# SERVICE BULLETIN

**SUBJECT:** Norco, Inc. A2972-1 and -2 Strut Assembly Rework to A2972-11 and -21

**A 2972-78-2**

FIGURE 1 TIP DIMENSIONS

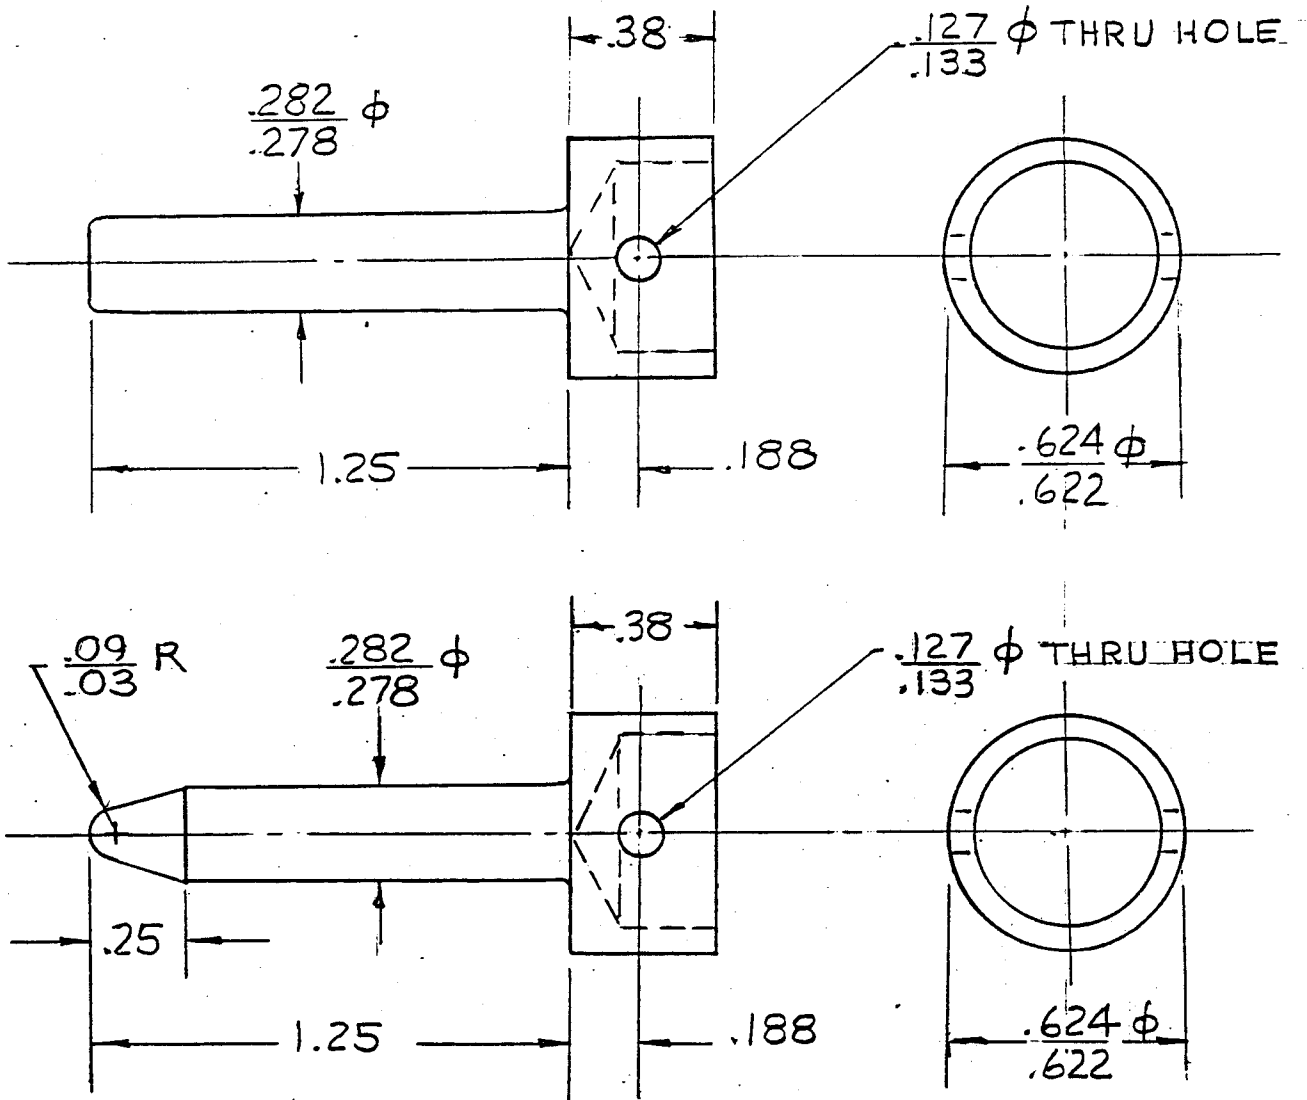
- 1) Remove tip by drilling out rivet in end of lock rod using a 0.125 inch diameter drill. Drill rivet on side with undeformed head.
- 2) Remachine tip end to new configuration shown in figure 1.
- 3) Repassivate per QQ-P-35
- 4) Insert tip into hole in lock rod and align rivet holes.
- 5) Insert a new rivet, part number MS20613-4C16, and spin or set head. Check that rivet head is properly formed without cracks.
